APPLICATION NO.	FILING DATE	FIRST NAMED INVENTOR	ATTORNEY DOCKET NO.	CONFIRMATION NO.
10/715,747	11/18/2003	Kenneth J. Kirchhoff	59137US002	5513
32692	7590	01/05/2006	EXAMINER	
3M INNOVATIVE PROPERTIES COMPANY PO BOX 33427 ST. PAUL, MN 55133-3427			CHANG, YEAN HSI	
			ART UNIT	PAPER NUMBER
			2835

Office Action Summary	Application No. 10/715,747	Applicant(s) KIRCHHOFF, KENNETH J.	
	Examiner Yean-Hsi Chang	Art Unit 2835

DETAILED ACTION

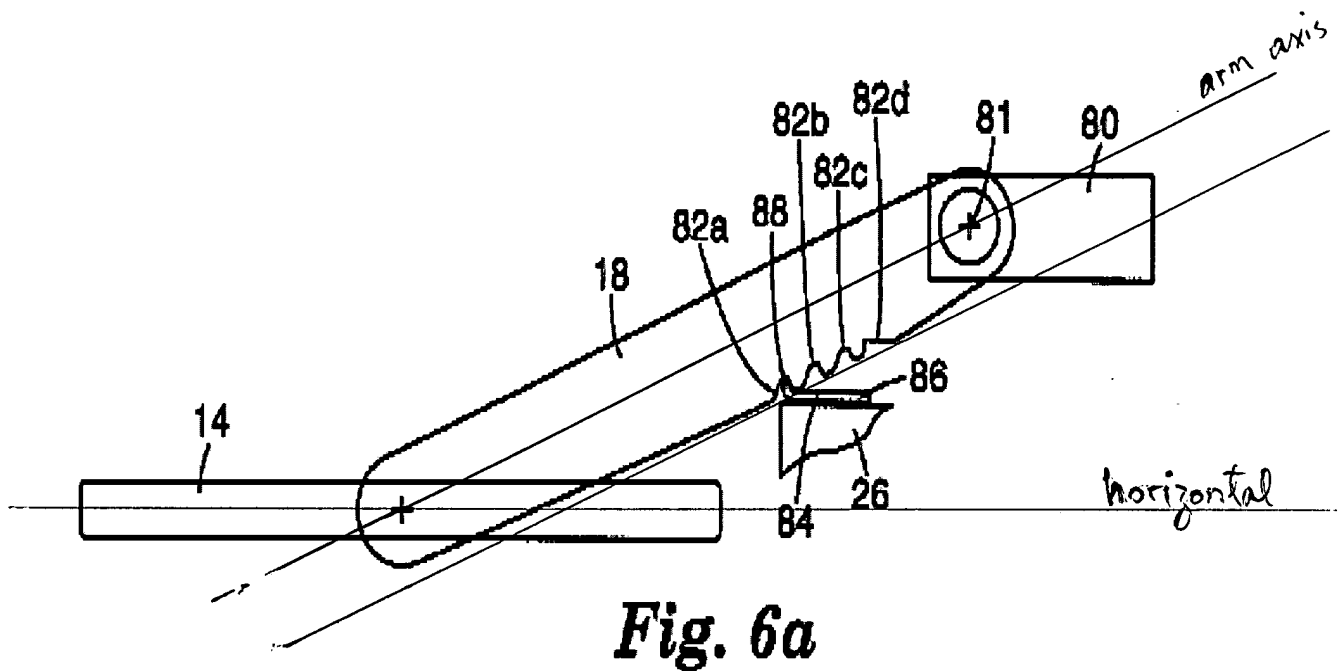
Regarding claims 1 and 18, Applicant argues, "Looking specifically at Figure 6a, if one were to draw an imaginary arm axis from the pivot point 8(1) to the point where arm 18 connects with keyboard tray 14, that imaginary line would be an arm axis. If one were to measure the vertical distance between notches 82a, 82b, 82c, and 82d and the imaginary arm axis, it would be all of the same height.", "the arm design of the '728 patent does not use a non-uniform arm, as Applicant has used in the instant application.", and "Furthermore, the '728 patent does not suggest the use of an arm design where the vertical distance between the notch and the imaginary arm axis increases."

As instructed by the Applicant, an imaginary arm axis is drawn in red in Fig. 6a of Hagglund as attached below, and a line parallel to the axis is also drawn in the Figure. It is clearly shown that the arm design of '728 patent does use a non-uniform arm (from 10.5 mm at the pivot point to 12.5 mm at the notches). The vertical distance between a notch and the imaginary arm axis varies as the arm rotates even though the distances between the notches and the imaginary arm axis are equal.
